Independent Technical Review of the George Massey Crossing

FINAL REPORT

September 2018

Reference: George Massey Crossing Independent Technical Review

Figure I Range of previous Project traffic forecasts⁴⁴.

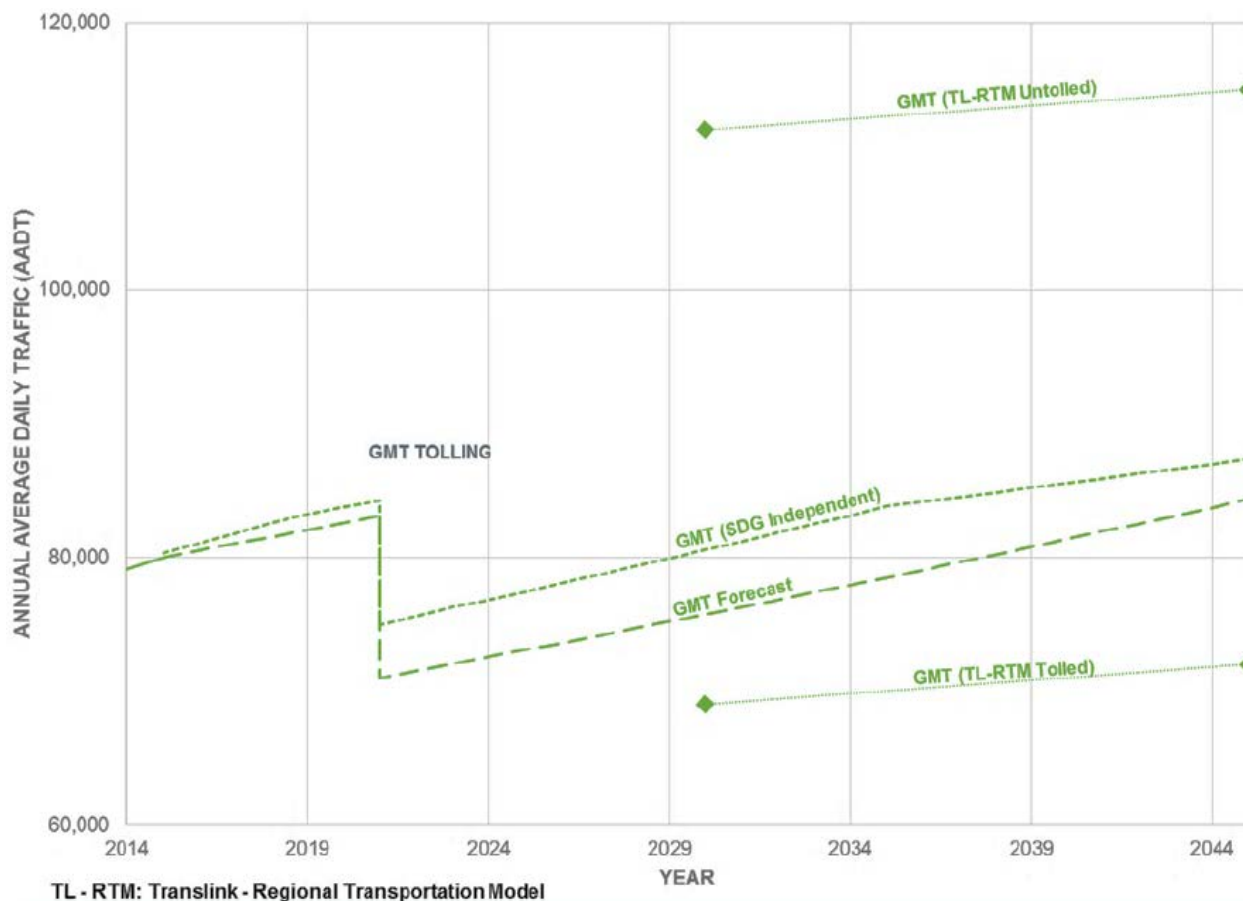
As part of developing the Project business case, several methods to forecast traffic volumes were employed with the "Project Forecast" being the officially adopted version that was used in the business case. Figure I provides a summary of the range of previous traffic forecasts that were developed. The following describes how the Project estimated traffic impacts and future demand levels. In each case, the models were generally developed using sound judgement and traffic engineering/travel demand modelling principles accepted in industry at that time. As such, the traffic forecasts result in reasonable estimates within the accuracy of the models available at the time. Lack of base year validation within the study area corridor, however, was a deficiency in some of these previous attempts. In other words, there was limited information that provided a comparison of the modelled versus observed travel conditions (i.e. traffic volumes, travel times, etc.) in the current year. This appears to be a deficiency in the project traffic forecasting that was undertaken.
